USB Type-C ENGINEERING CHANGE NOTICE

**Title: Change reference Footprint for a USB Type-C Mid-Mount Dual-Row SMT Receptacle.
(Section 3.2.1, Figure 3-7 of Page 37)**

Applied to: USB Type-C Specification Release 1.0, August 11, 2014

Section 3.2.1, Figure 3-7 of Page 37

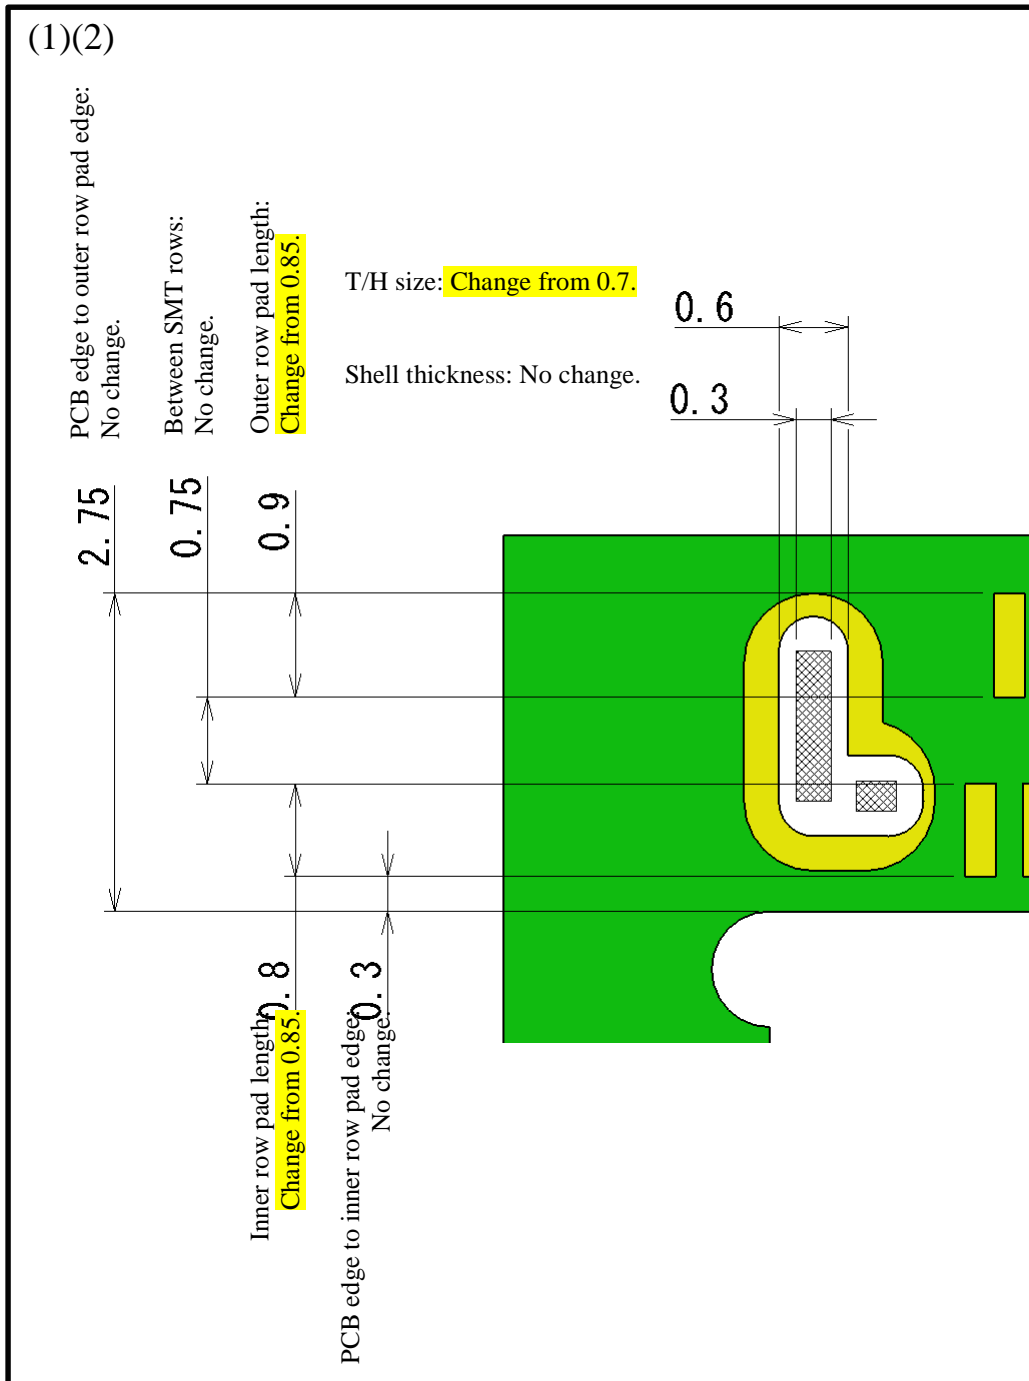
- (1) T/H size got smaller for shell tabs. (Tightened the clearance with shell tabs.)
- (2) C/T SMT pads at an outer row were extended by 0.05mm.
C/T SMT pads at an inner row were shortened by 0.05mm.
No change for a distance between SMT rows.
No change for the near end position of the inner row of pads. etc.

- (1) Benefit is better final post-soldering positioning, improved control of movement during re-flow process.
- (2) No negative impact.
